Schematic,
MEP DPU DPUGLU Actel

APPROX. SEQ+COMB MODULE COUNT: 503+765=1268

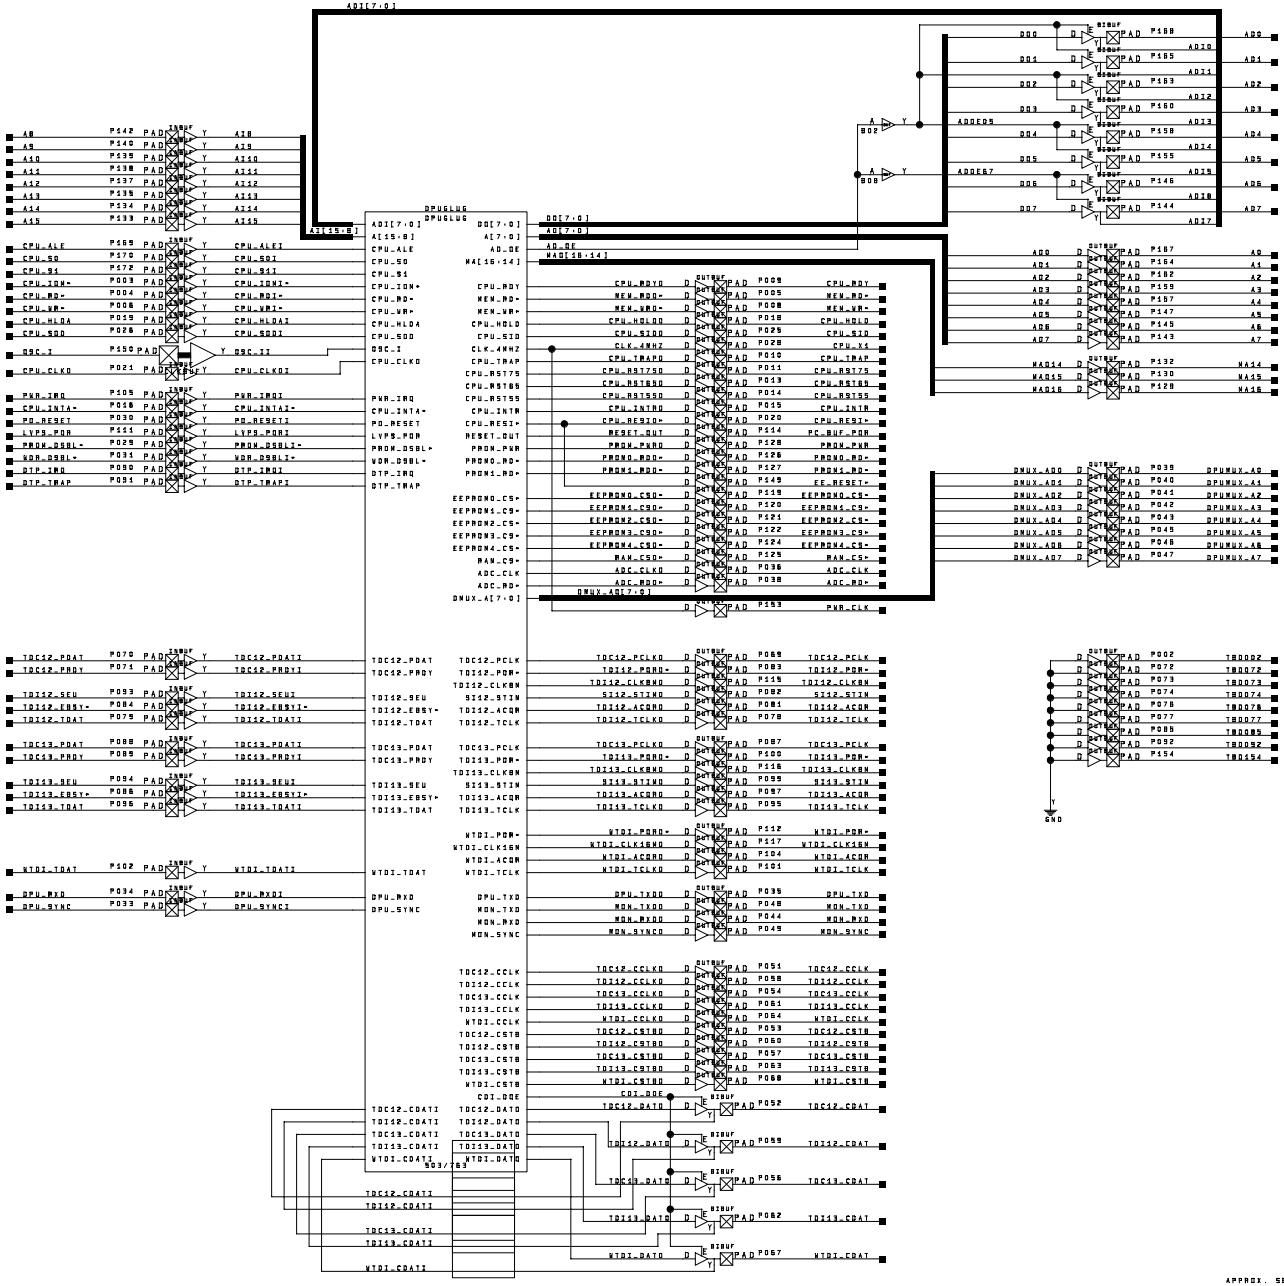
A	1997-10-15	First Release.
B	1997-10-20	Eliminate initial power-up glitch on FDT, FAX Reset FFs in TDM_RX; fix CPU_TDM was CPU_TDM; TDM_TX outputs use O.C.; add PWR_CLK output for DPUPWR; use GDR2 on ~CLK32M.
C	1997-11-20	Add proper control setting to outputs; make stim pulse 1 us wide; add ADC 1/2Hzout sel; fix ADC1 clock; add ADC2 interrupt; add ADC2 Reset; add ADC2 enable; add interrupt mask; Interrupt Requests performed; add IRQ0 to TDM_RX at port D3
D	1998-01-07	Fix UART_CLK rate at 38.4 kb/s (was 55.8 kb/s); add downcount timer; add reset status FFs; remove A[15:14] status bits.
E	1998-01-28	Fix TIMER_WR I/O speeds; fix DCN1_LOCK; fix S1 STIM power-saving; fix BSRF 2.3 errata; fix CDI; add enable power-up; fix CDI readback test; delete SEC_RESET port; fix SEC_CLK from; add SCT Start; add STAC pulse decode; fix SEC INIT timing; revise PRR17 status bits; simplify address latches.
F	1998-02-22	Simplify WR/DWR*; add DPUGLU rev port; major PMA revs; add SC_REV port; fix sum & hash latches; fix CDI state decode.

G	1998-03-09	Upgrade REV ports; fix SCT_LD_ENBL issue; add MUX on WDG_RDO; add TDI reset control; LVPS_POR was active low; delete CLK8 input (pin 184); add TDI32_SEU; TDI13_SEU; finish TDI_MX block; fix PCLK error in PMA; change TX FCOM_Reset to FF; add compatible SEC start errors; add CLK, CAT, CTB, CLK, PCAT, PRST between TDC12 & TDC13; change MUX48 to MUX48U.
H	1998-05-04	Upgrade REV ports; fix SB; fix TDI_RX bit, byte, word, and step timing; add TxREV FF in TDI_RX.
J	1998-06-21	Upgrade REV port to 0A; fix TDI_RX TCLK FF stop input; add TDI readout SR load.
K	1998-06-24	Fix TDI_MX serial clock output.
L	1998-06-25	Upgrade REV port to 0C; fix TDI acquire pulse decode; fix PMA timing logic errors.
M	1998-07-21	Upgrade REV port to 0D; change WIC clk from 32 to 1.8 MHz.
N	1998-08-25	Upgrade REV port to 0E; fix UART TX DVB bit; add separate loopback; simplify TIMING, UART, TDI_RX, REV_DEC, INT_MUX; add TDI readout buffers; revise compression; delete many buffers; simplify extensively.

P	1998-09-16	Upgrade REV port to 10h; fix SMUX-A9 message in REV_DEC; fix 24-28 compr error; at RX41-D0; fix TDI MS site for shift/compr; fix BC-12 decode for shift/compr.
Q	1998-09-24	Upgrade REV port to 11h; fix TDI RX logic.
R	1998-11-11	Upgrade REV port to 12h; add reset to CDI CLK output FF.
